CITY OF ALBUQUERQUE

RE: **Kidz Academy**
McMahon and Fineland NW
Grading Plan and Drainage Report
Engineer's Stamp Date 1/18/18 (File: A11D016)

Based on the information provided in your submittal received 1/18/18, the Grading Plan and Drainage Report cannot be approved until the following are corrected:

TYP. ORIFICE PLATE DETAIL
N.T.S.

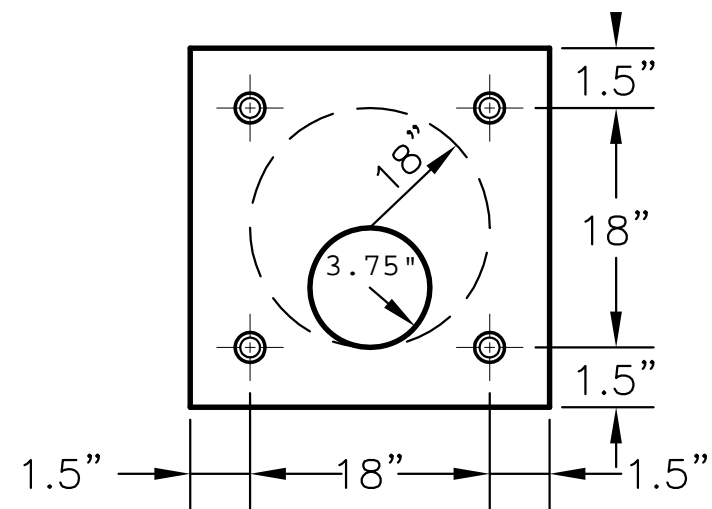
7. Please specify a square opening on the orifice plate.
8. Please label this Grading Plan as "conceptual, not for construction" or similar.
9. How is the roof drainage routing through a first flush/detention pond? The drains appear to be plumbed directly to the private storm drain. More detail is need on the ponds and storm drains to demonstrate that they will intercept flows and adequately restrict discharge from the site.
10. Quantify the volume of first flush bypass and state on plans. It appears there may be some bypass from the drive entrance, but it is unclear with the new ROW line.
11. This site has been graded several times and no land treatment A remains, Please update the proposed Hydrology to reflect.
12. There are two Basin C's on the subbasin map and no Basin A; Please correct.

ENGINEER'S SEAL 1/18/18	KIDZ ACADEMY	DRAWN BY WCWJ
	GRADING AND DRAINAGE PLAN	DATE 9-25-17
	 1606 CENTRAL AVENUE SE SUITE 201 ALBUQUERQUE, NM 87106 (505) 872-0989	21801-LAYOUT-9-25-17
DAVID SOULE P.E. #14522		SHEET # 21801

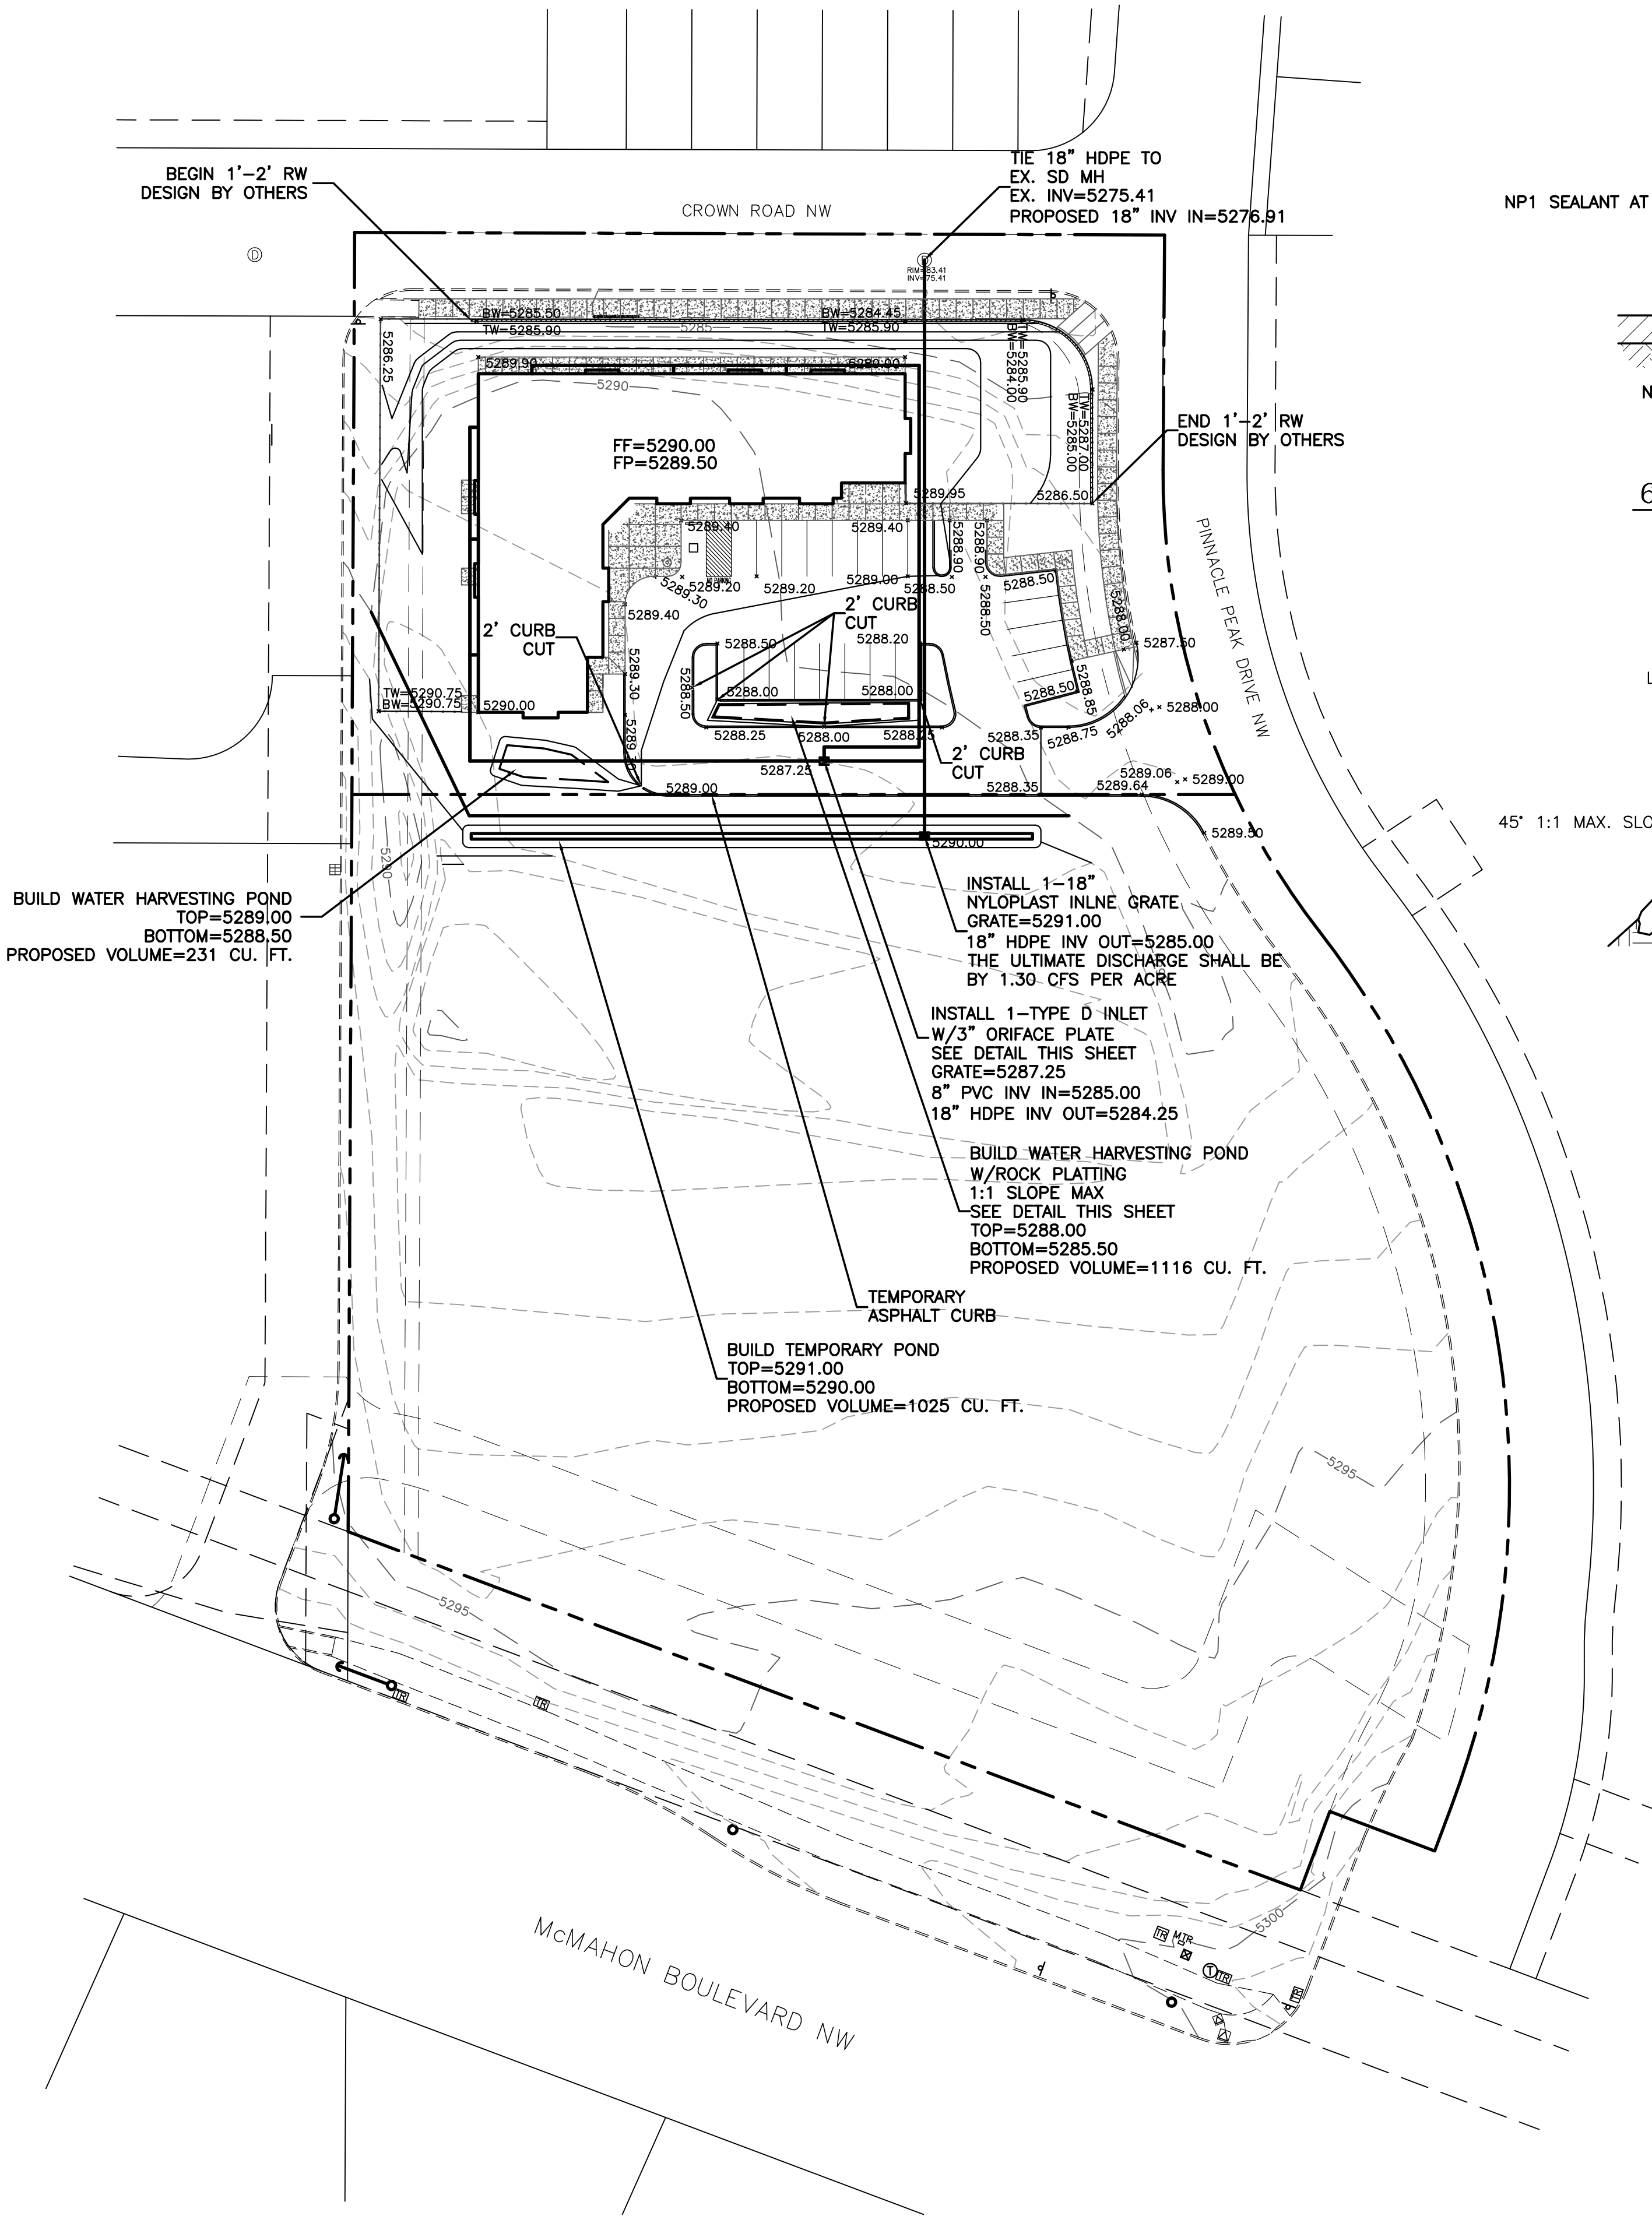
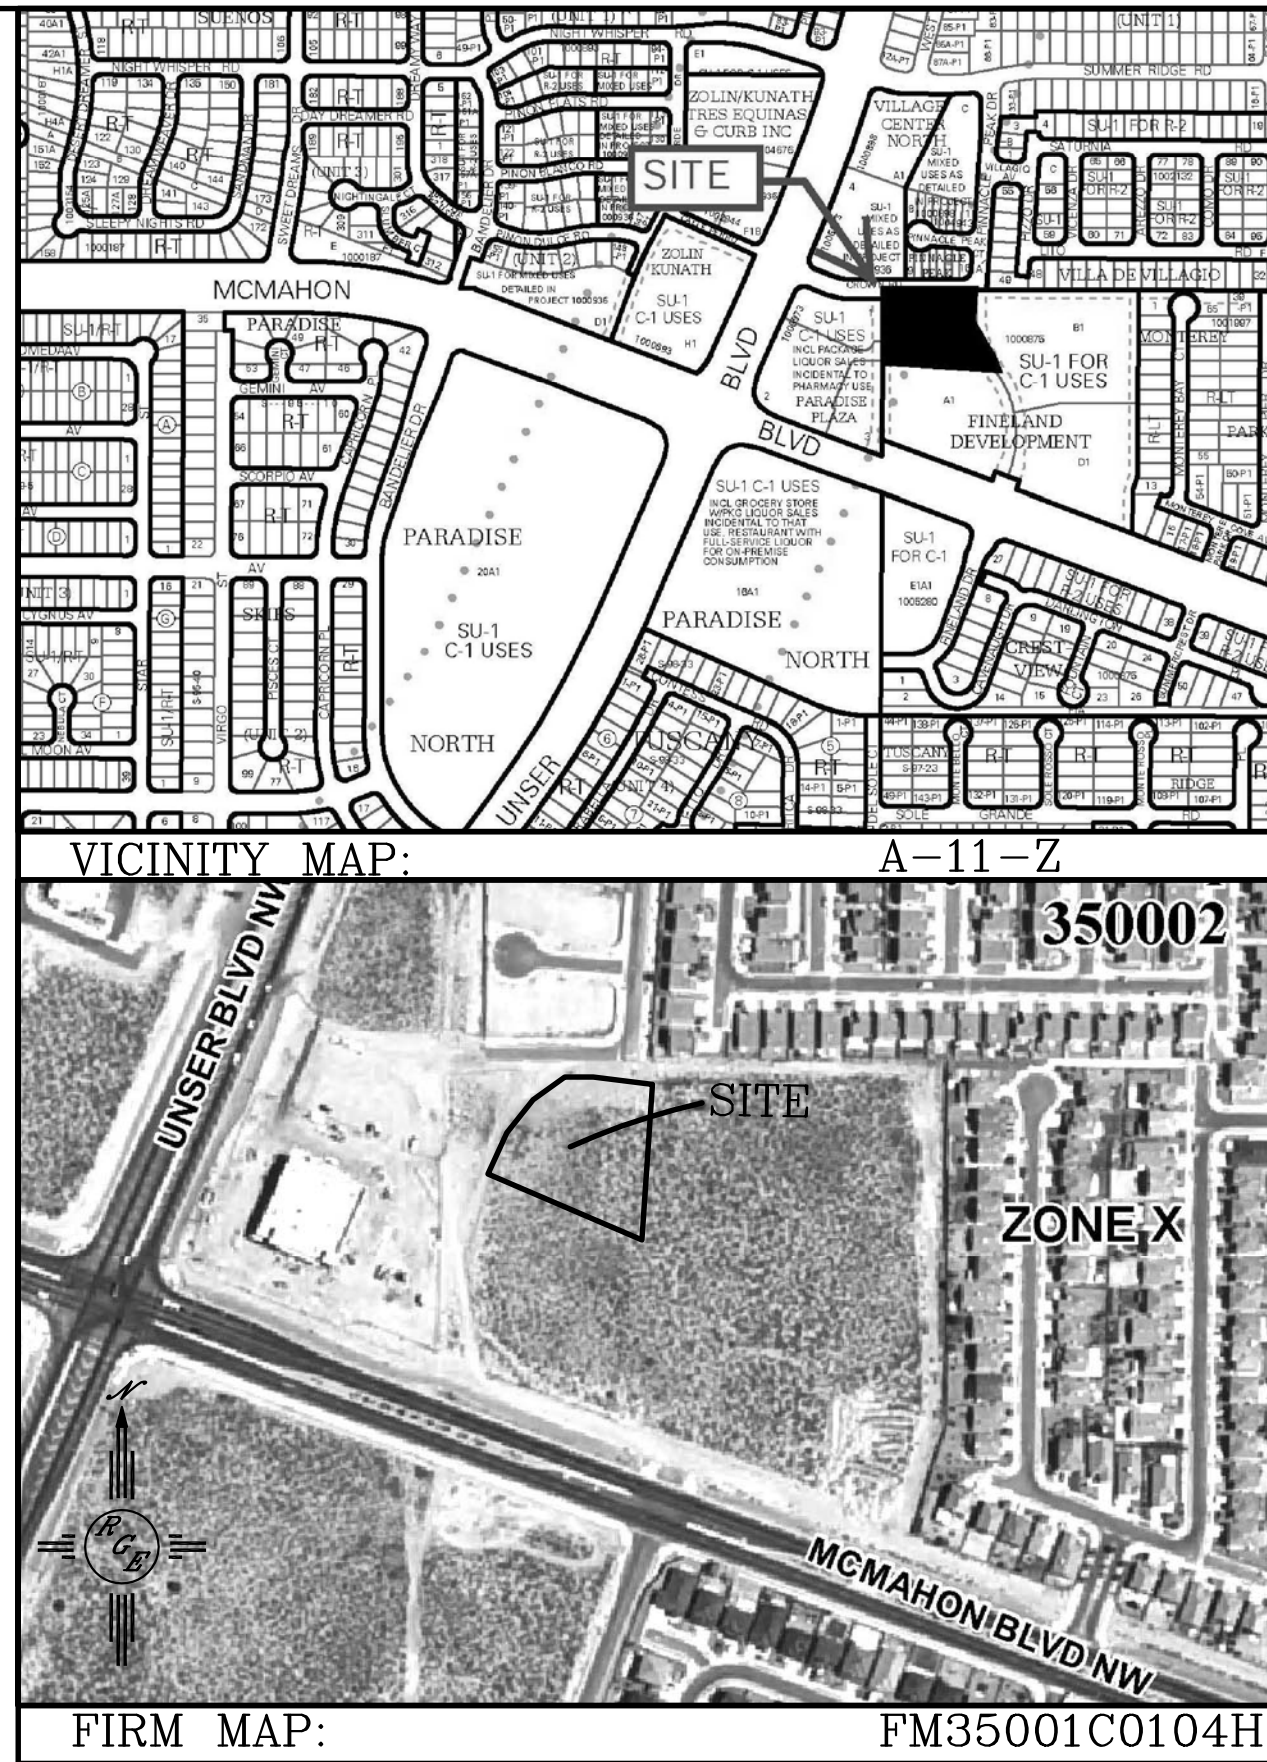
1. The current approved grading plan (Goodwin-2018) and the new plat allow blanket cross lot drainage to a new pond (not constructed) with zero discharge from this larger site. This plan will need to restrict upstream discharge from Lot A1B with a new pond on lot A1B restricting discharge to at least 1.3cfs/ac. A Drainage Covenant (no public easement) will be required for this pond and be granted by the owner of Lot A1B.

5. Provide RCP CL III pipe in the Crown Road ROW. There should also be an existing 18" RCP pipe with drop inlet coming from this manhole and onto the property; why not make use of that? This drainage connection will also need to be listed on the Infrastructure List.

6. Show the new lot lines on the grading plan, including the ROW takes for Crown and Fineland.
